Proposal of low frequency jitter specifications for 10G-EPON

Mitsubishi Electric Corporation

Mask of the sinusoidal component of jitter tolerance

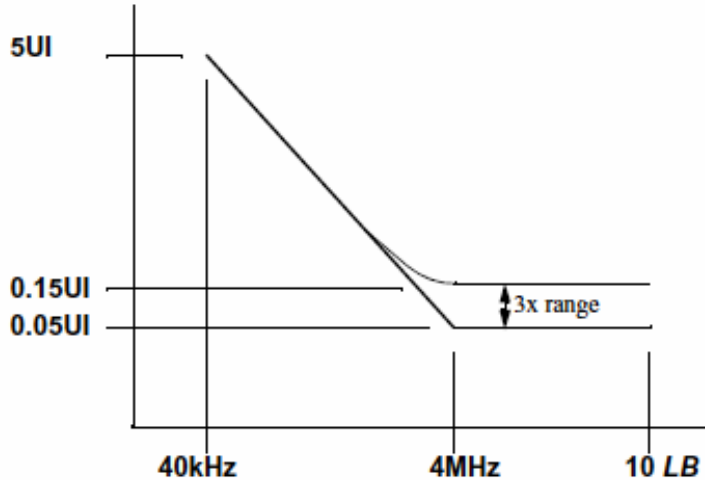
Define the “Mask of the sinusoidal component” as the jitter tolerance specification.

-> For modification of draft, we should add the following sentence to clause 91.7, and add new table as below Figure 91-xx.

“The jitter tolerance under the condition including lower band than corner frequency for 10GBASE-PR10/20/30 are specified in Table 91-xx.”
